#13113: Service Update for Inventory and Customer Vehicles - Convertible Top Cosmetic Blemish - Expires with Base Warranty - (Apr 16, 2013)

Subject: 13113 – Service Update for Inventory and Customer Vehicles – Convertible Top Cosmetic Blemish – Expires with Base Warranty

Models: 2013 Chevrolet Camaro Convertible

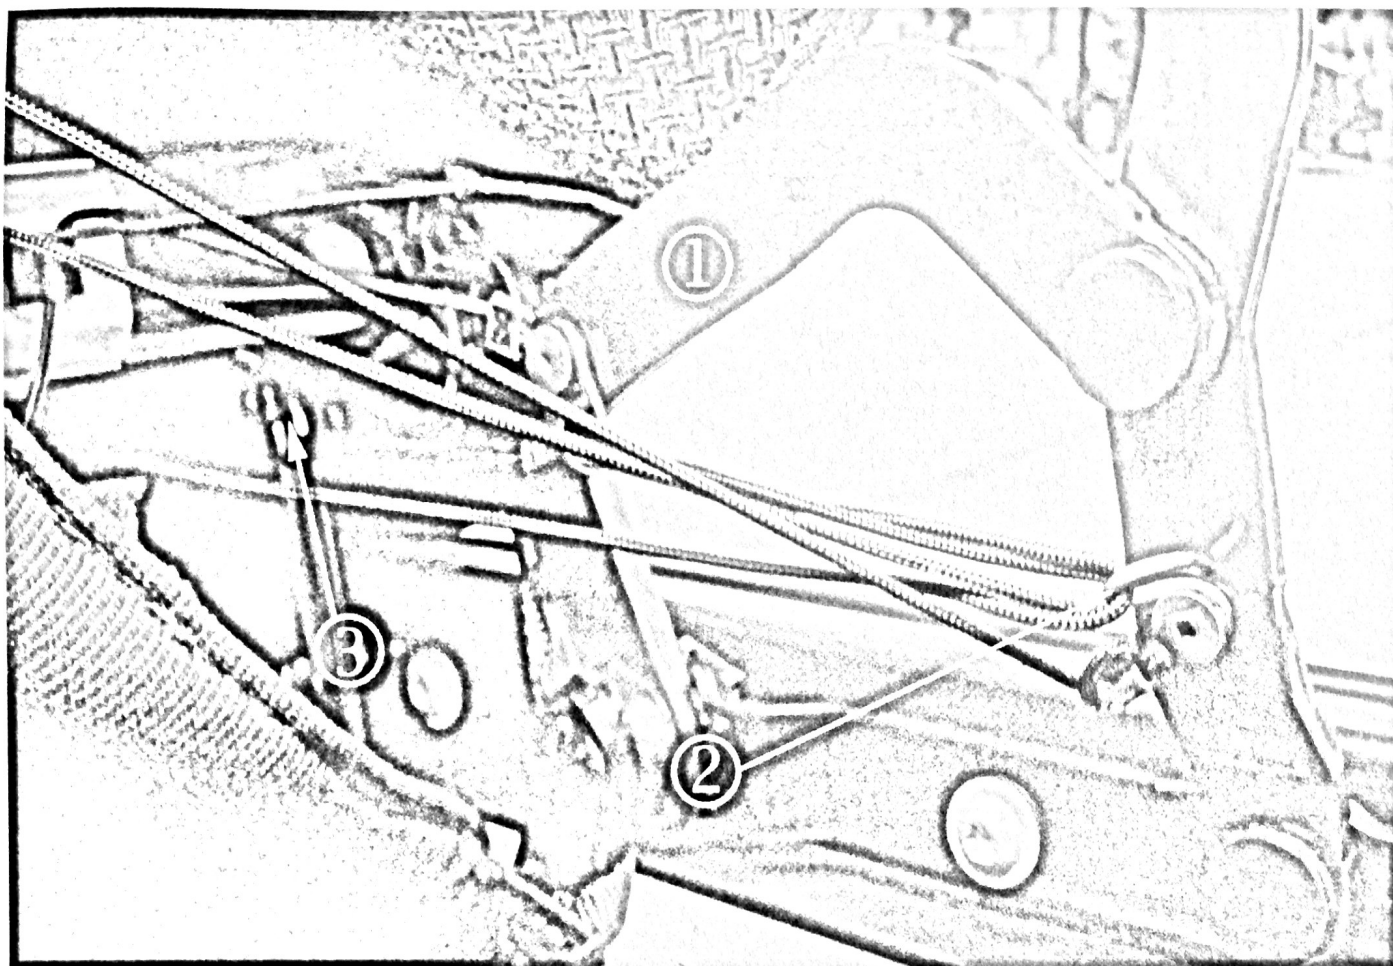
1. Open the convertible top to the half-open position.
2. Locate the convertible top control link (1).

- Note:** (1) Control Link (2) Control Link Front Eye Loop (3) Control Link Rear Eye Loop
3. Locate the control link rear eye loop (3). Refer to the inside of the control link to locate the rear eye loop.

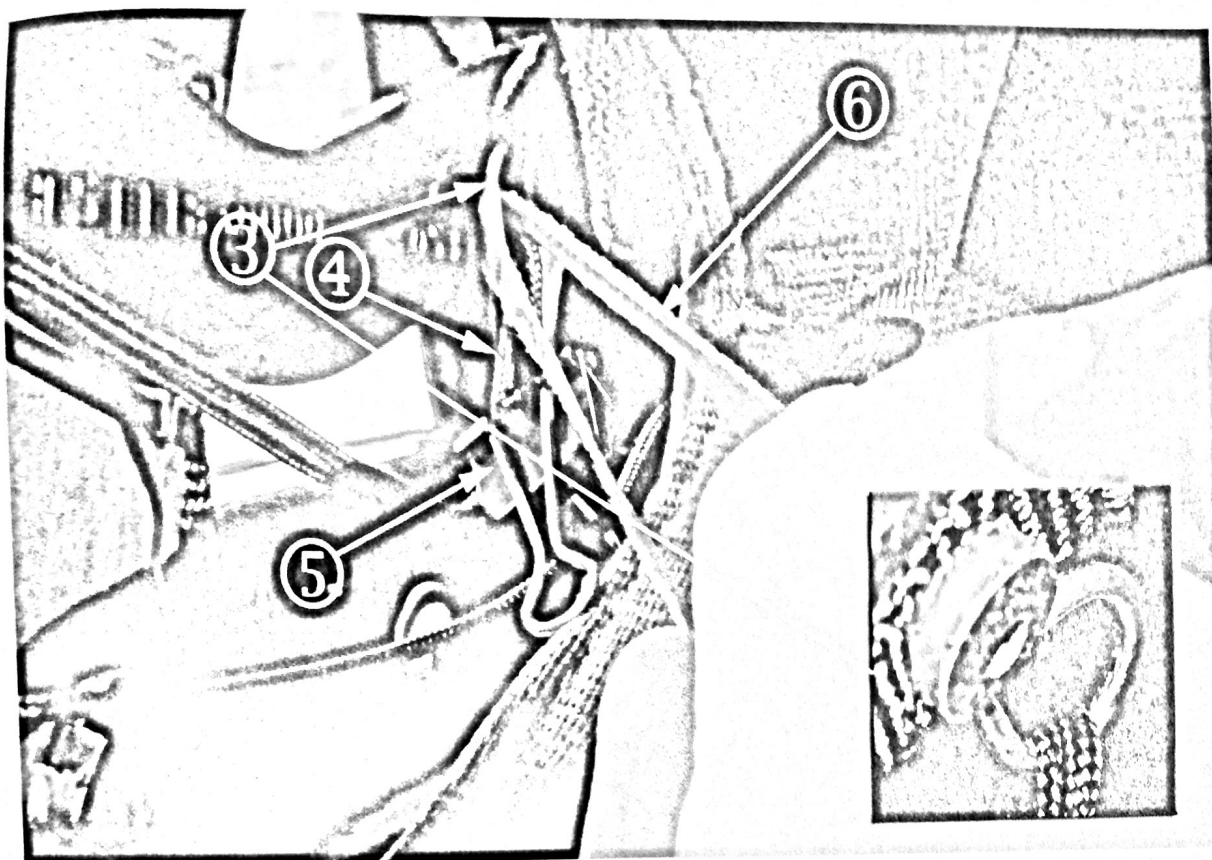
4. Pull down on the rear eye loop cord (4) and secure it with a binder clip (5) or equivalent to expose the inside surface of the rear eye loop.

Note: Only polish the control link rear eye loop. Do NOT polish the control link front eye loop.

5. Use a piece of 320 grit emery cloth (6) that is 5 mm (0.197 in) wide and 80 mm (3.15 in) long to polish the inside surface of the eye loop (3). Spend about 3 minutes polishing each rear eye loop (3) to ensure any burrs or rough edges have been removed.
